ADDENDUM NO. 3

**Replace Roof and Repair Concrete & Brick
Hearnes Complex Buildings
Fulton State Hospital
Fulton, Missouri
PROJECT NO.: M1803-01**

ADDENDUM #3

REVISED DETAIL 1 / A503

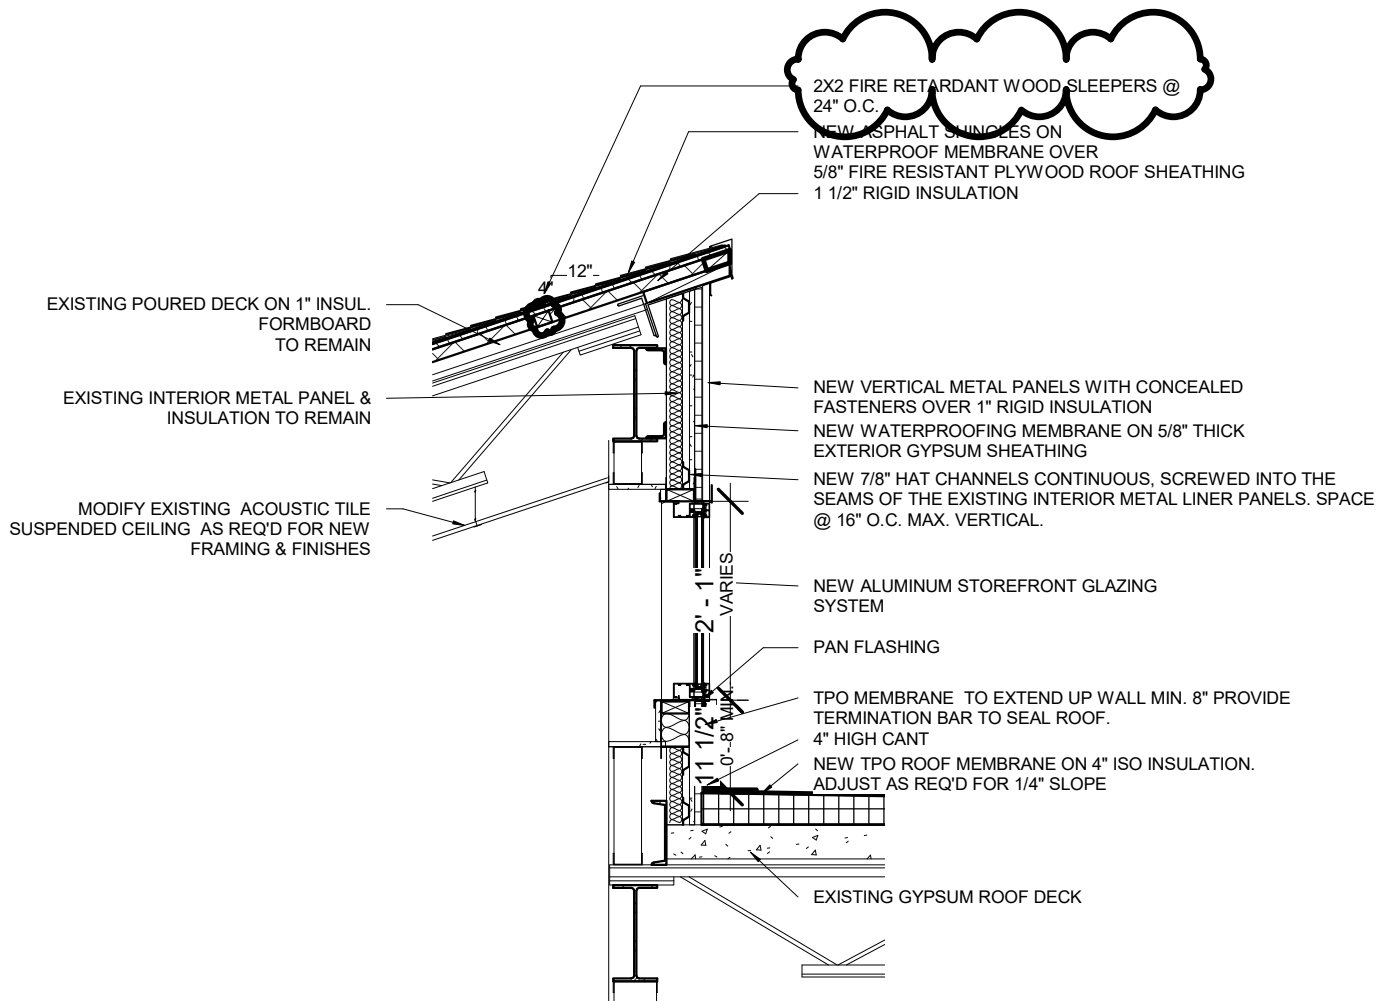
1. SHEET A503 – Building Sections
 - a. REVISE Drawing A503, Detail 1/Section Through Clerestory and Detail 2/Section Through Clerestory W/O Window per REVISED DETAIL 1/A503 and REVISED DETAIL 2/A503 (attached).
2. SHEET A504 – Detail Sections
 - a. REVISE Drawing A504, Detail 2/Chimney Removal Cross Section and Detail 4/Clerestory Header Detail per REVISED DETAIL 2/A504 and REVISED DETAIL 4/A504 (attached).

1 SECTION THROUGH CLERESTORY
1/2" = 1'-0"
